WSRC-TR-2004-00106
Revision 0

**GROUNDWATER FLOW MODEL OF THE
GENERAL SEPARATIONS AREA USING PORFLOW (U)**

JULY 15, 2004

Figure 2-8. Example velocity field showing predominantly downward flow in the vadose zone; vectors are fixed length showing flow direction only.

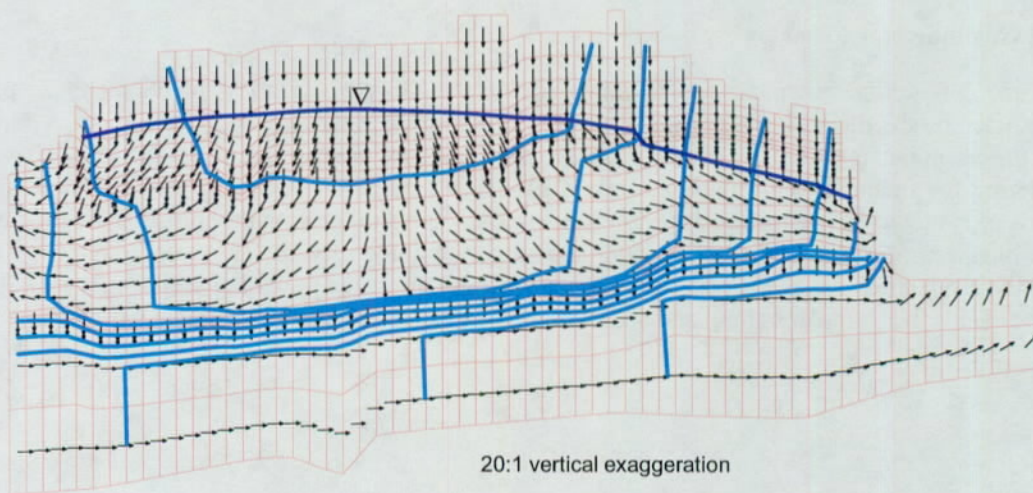
| Document Review Comments | | | Page 3 of 5 |
|------------------------------------|---------------------------------|--|---|
| 26 | Page 12 | In Figure 2-8 can you show a line that delineates the water table (red line)? | Water table marker added |

Figure 3-2. Simulated hydraulic head in GSA/PORFLOW model at cross-section through E Area (I=50).

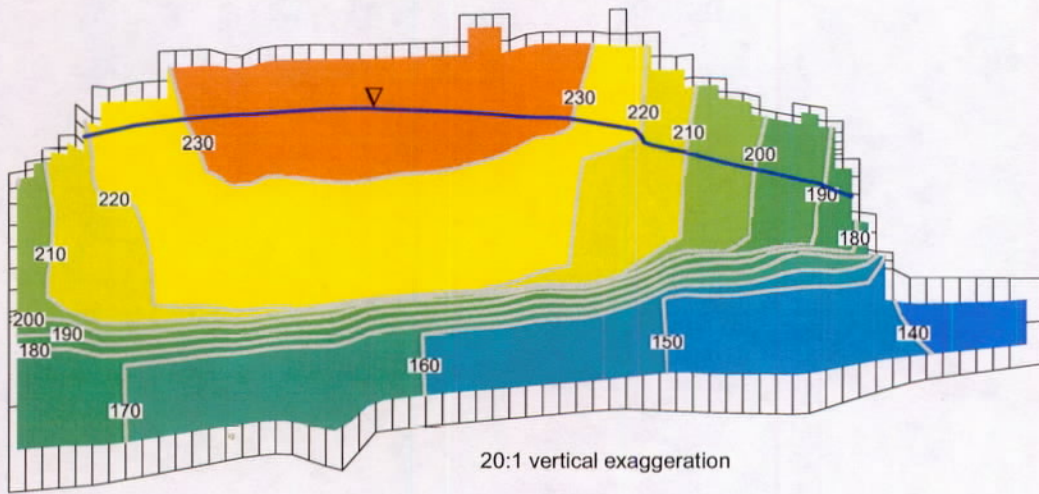
| Document Review Comments | | | Page 3 of 5 |
|------------------------------------|---------------------------------|--|---|
| 30 | Page 15 | What is the significance of the model cross-section at I=50? | Caption revised to indicate slice through E Area |
